Monticello Nuclear Generating Plant

License Amendment Request Dated July 26, 1989

Proposed Changes Marked Up on Existing
Technical Specification Pages

REVISED TECHNICAL SPECIFICATION PAGES

FIGURE 3.11.1 MAPFAC_p LIMITS

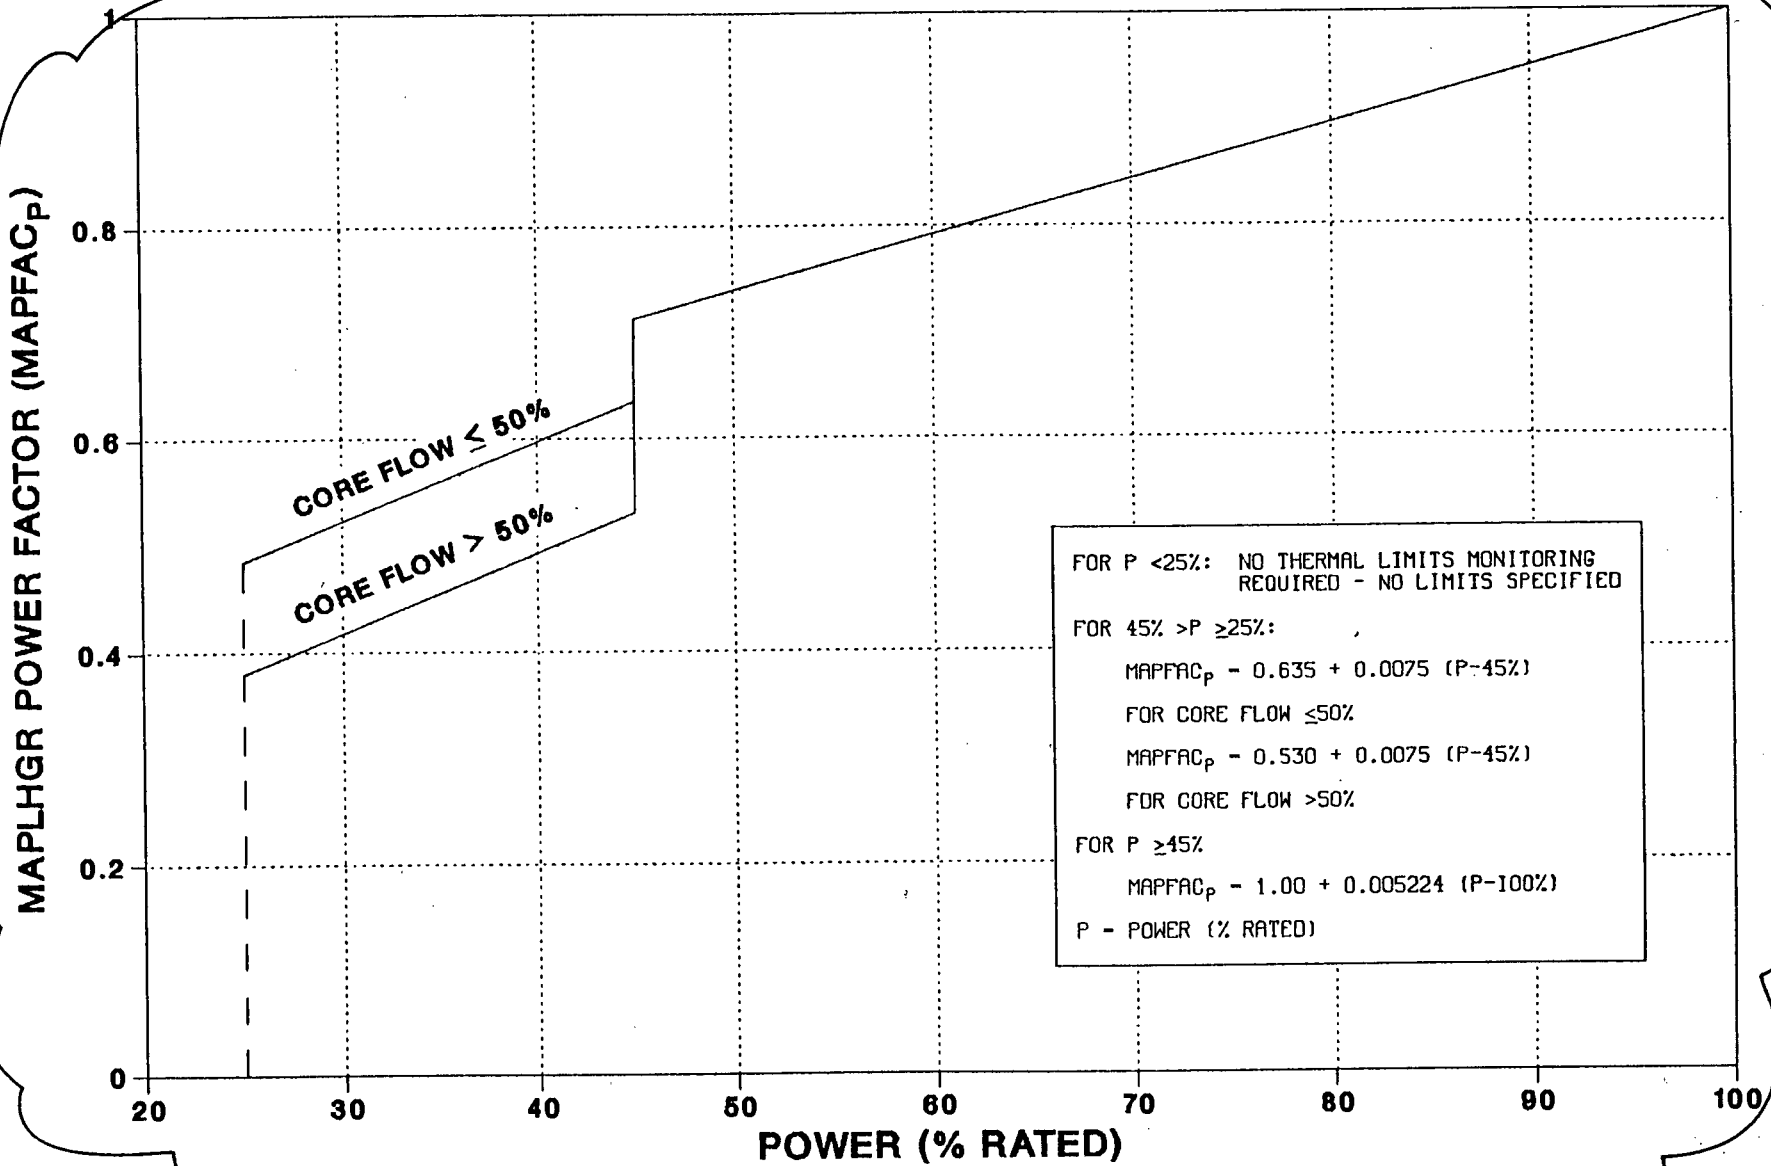
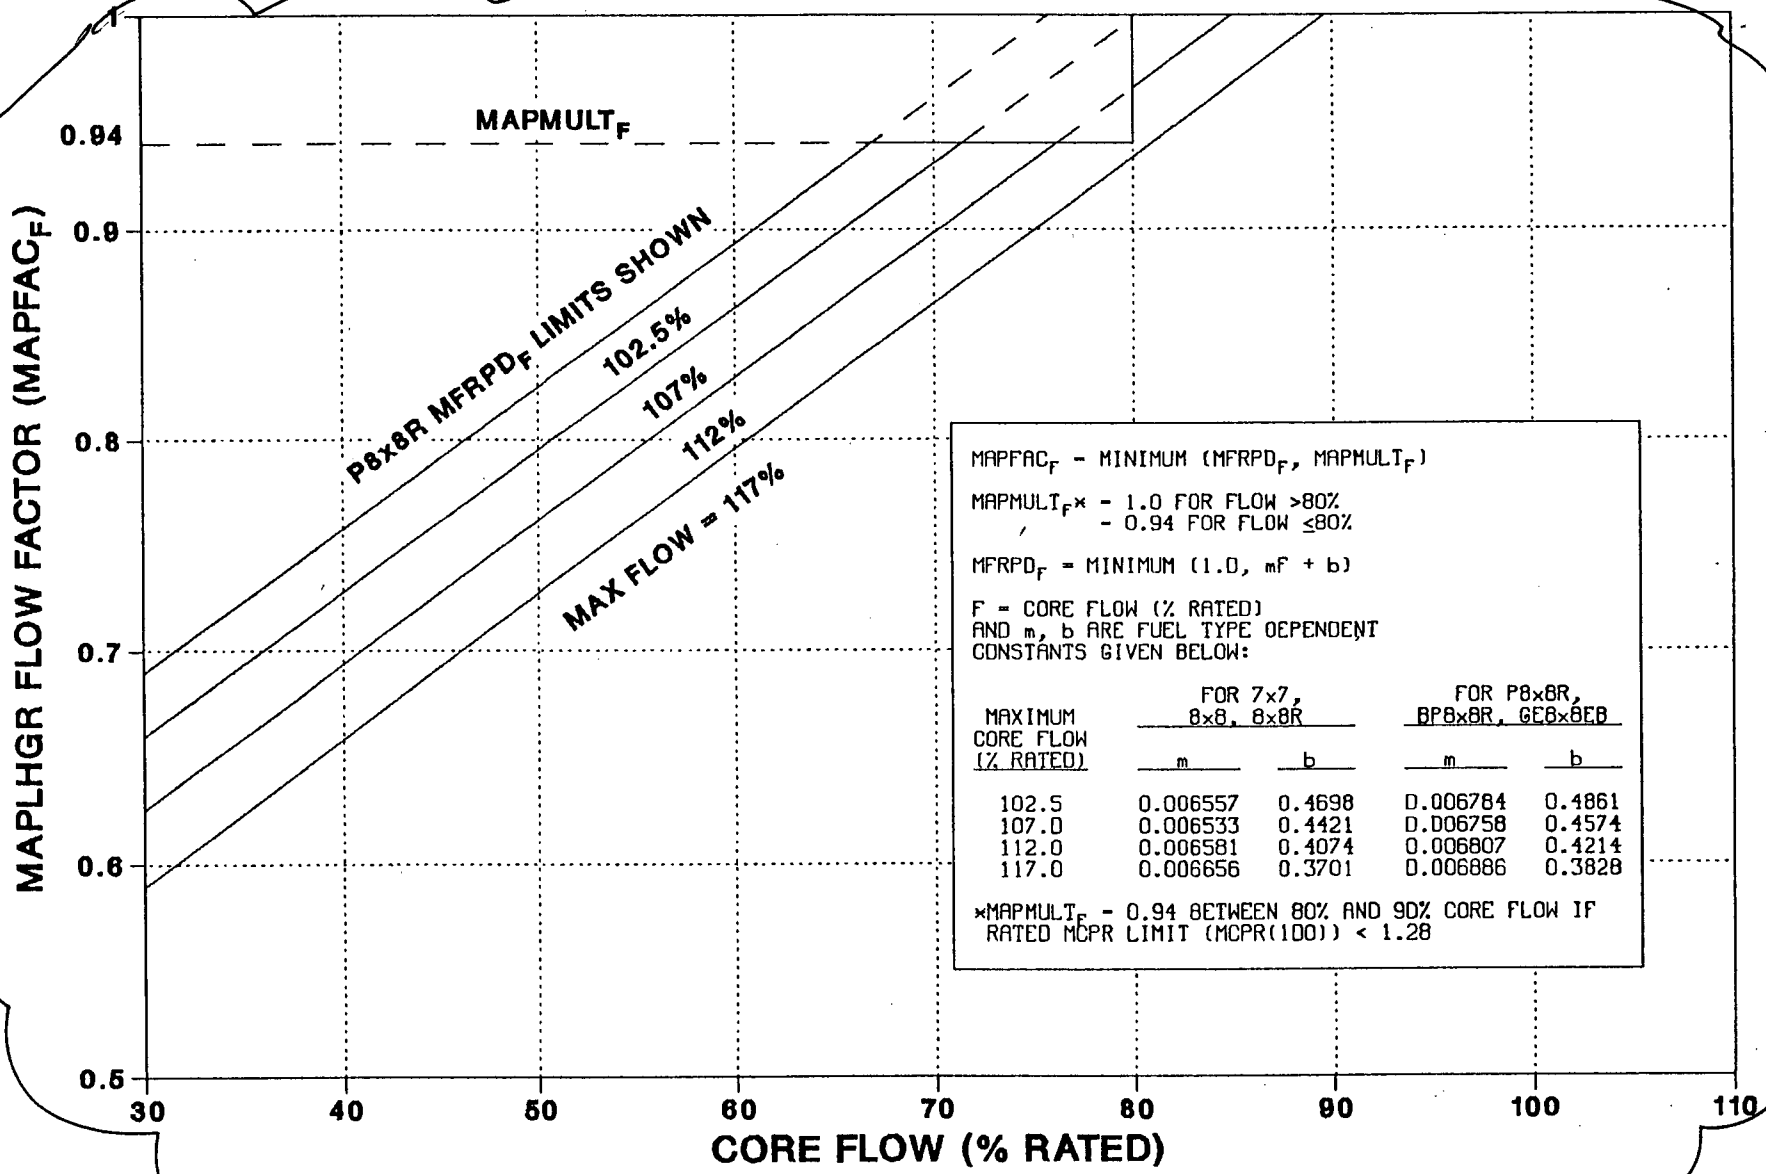
*Move to the Core
Operating Limit Report*

*Move to the Core
Operating Limits Report*

FIGURE 3.11.3 POWER DEPENDENT MCPR LIMITS

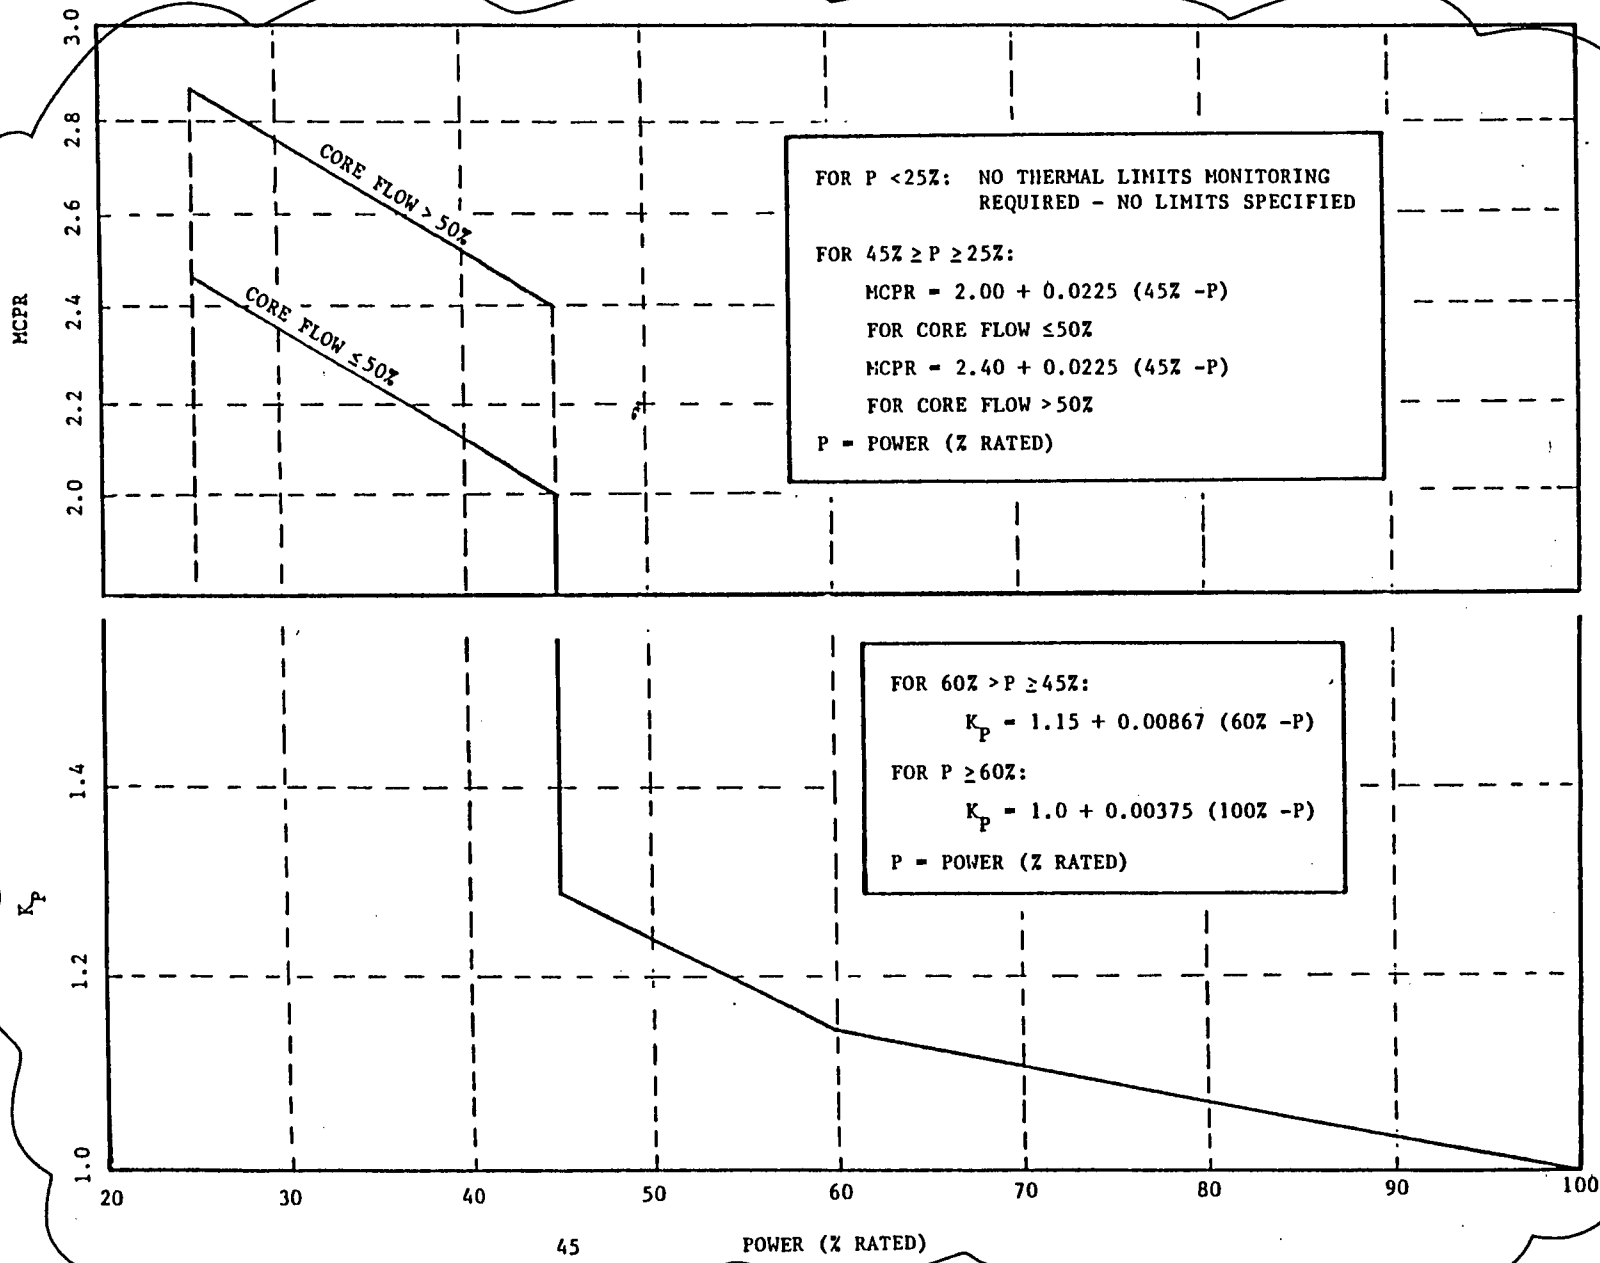
*Moved to the Core
Operating Limit Report*

*Move to the Core Operating
Limit Report*

FIGURE 3.11.4 MCPR_F LIMITS

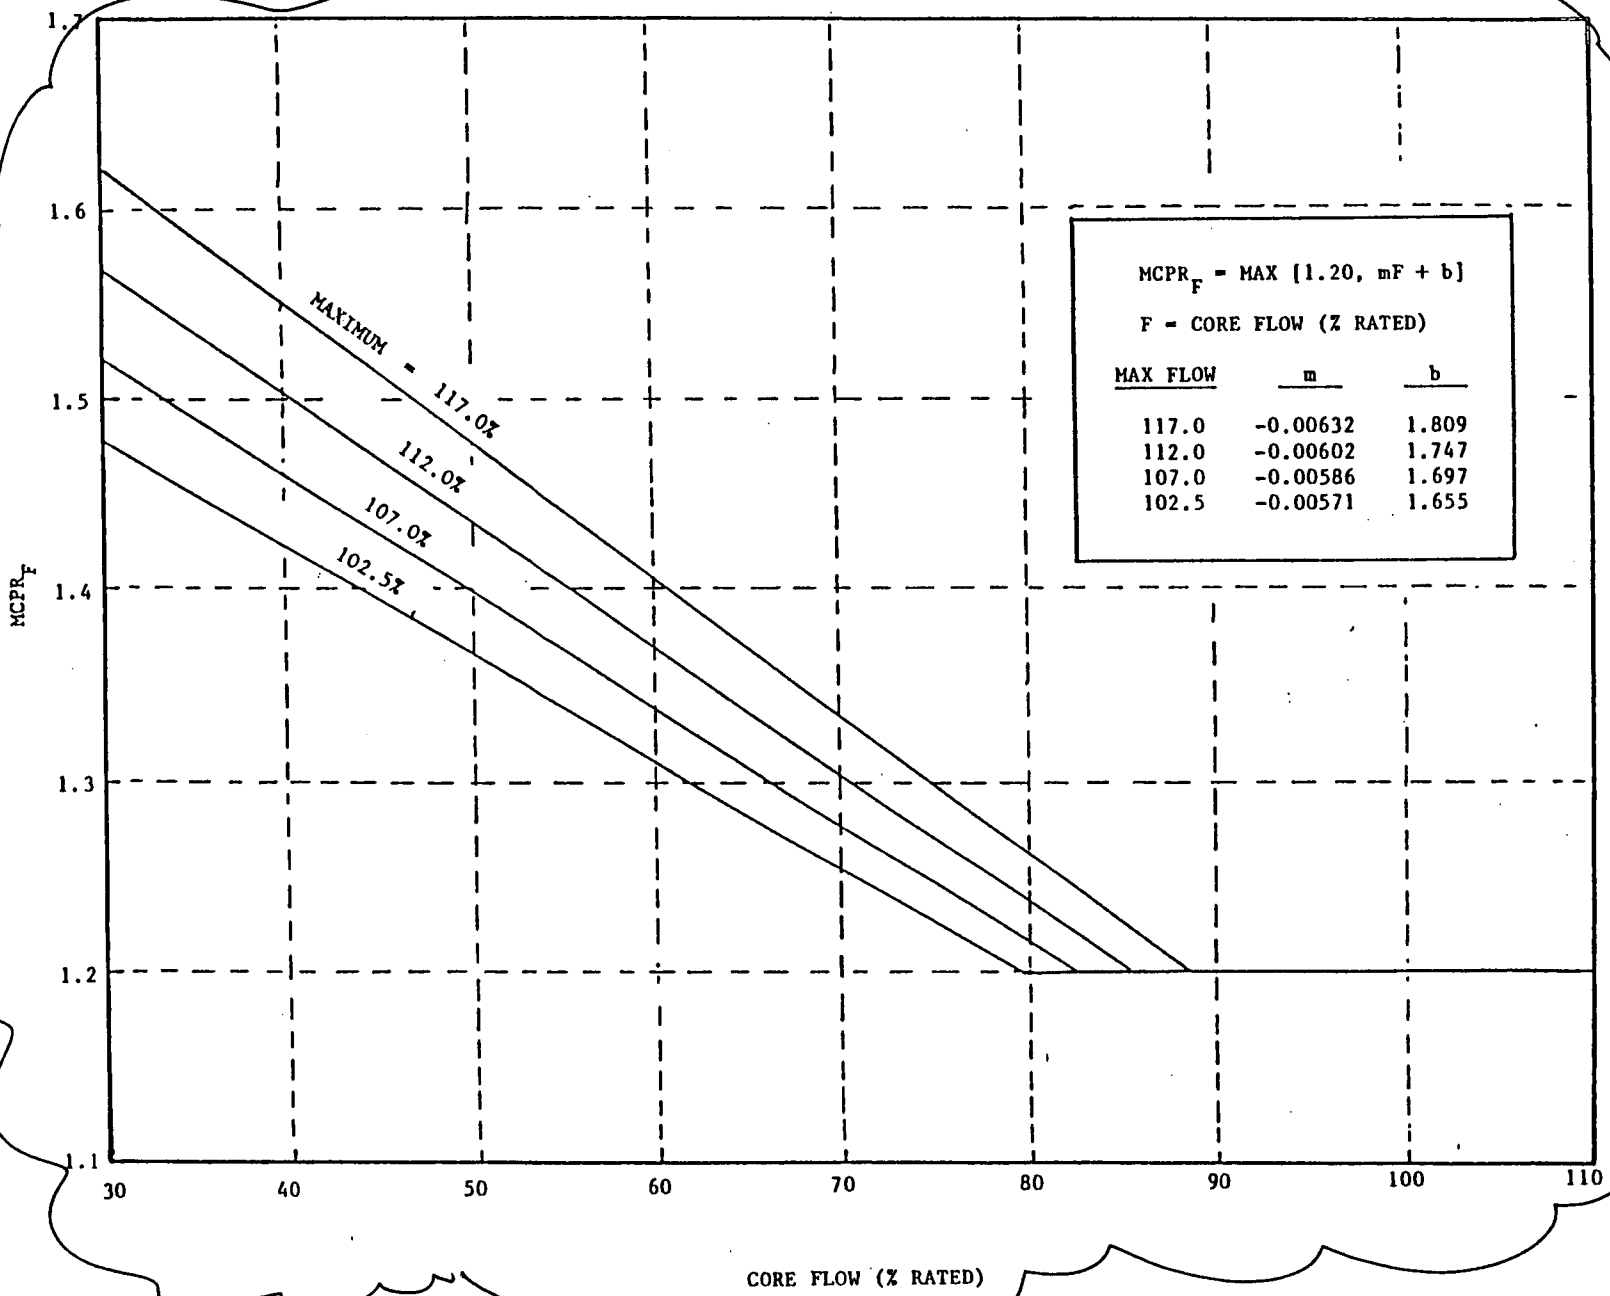
provided in the Core
Operating Limits Report

FIGURE 1 MAPFAC_p LIMITS

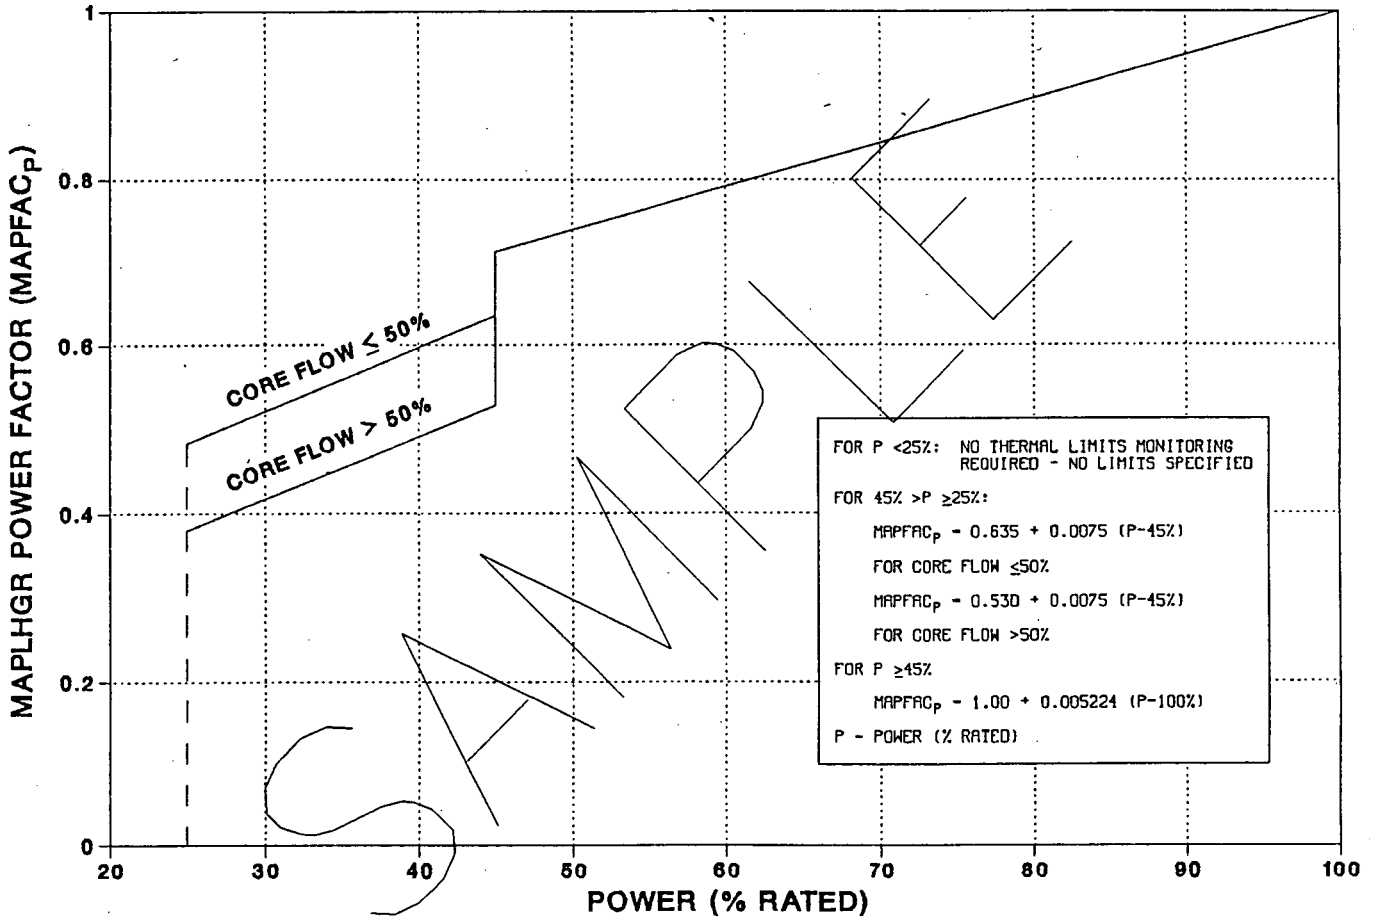
When hand calculations are required, the Maximum Average Planar Linear Heat Generation Rate (MAPLHGR) for each type of fuel as a function of average planar exposure shall not exceed the limiting lattice (excluding natural uranium) provided in Table 1 (based on straight line interpolation between data points) multiplied by the smaller of the two MAPFAC factors determined from Figures 1 and 2.

FIGURE 3 POWER DEPENDENT MCPR LIMITS

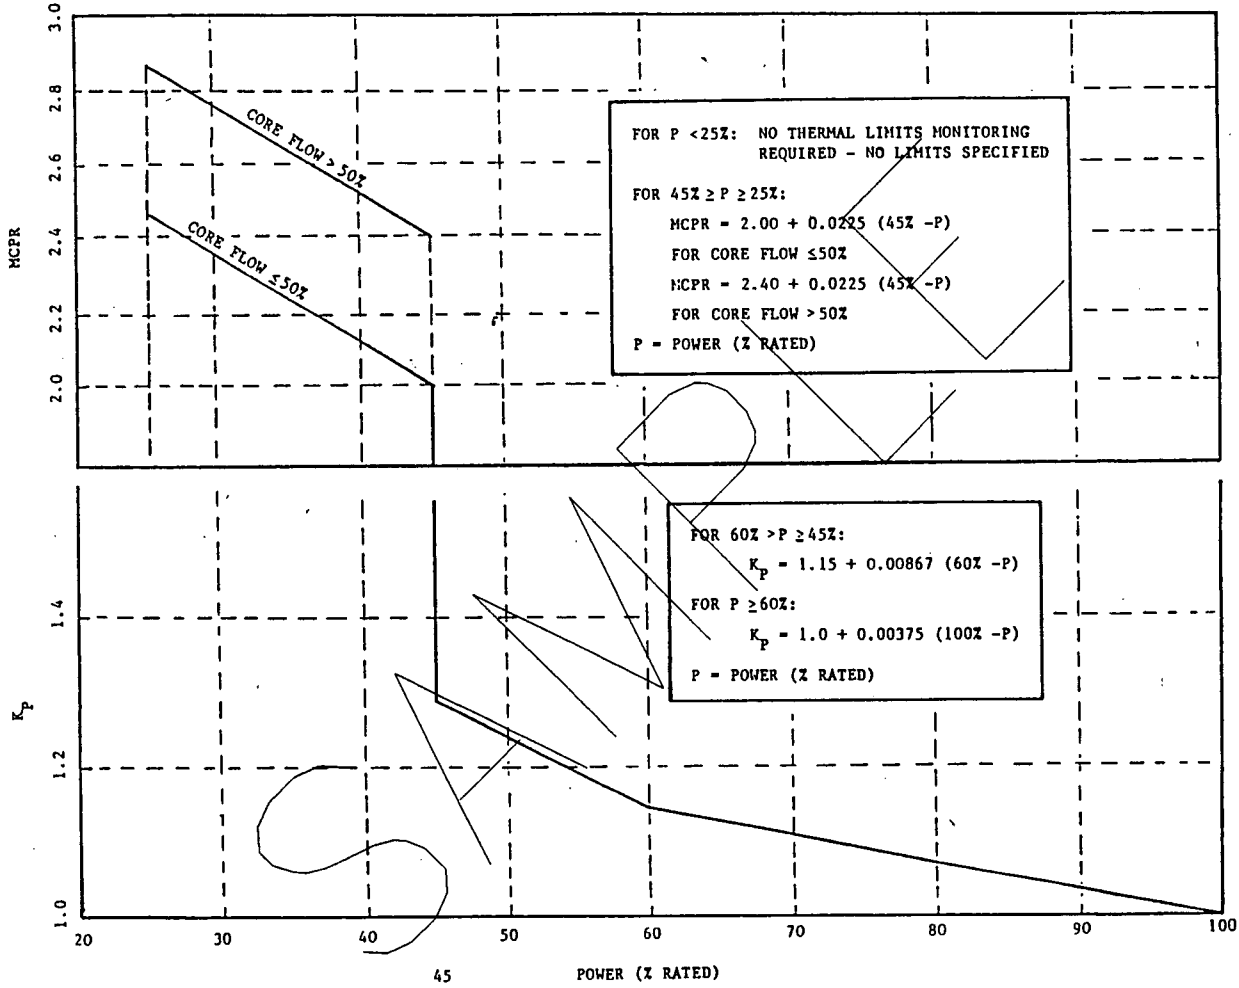
1.30 x K_p (K_p from Figure 3) or the $MCPR_f$ from Figure 4.

If thermal power ≤ 45%, then the MCPR limit is obtained from Figure 3.
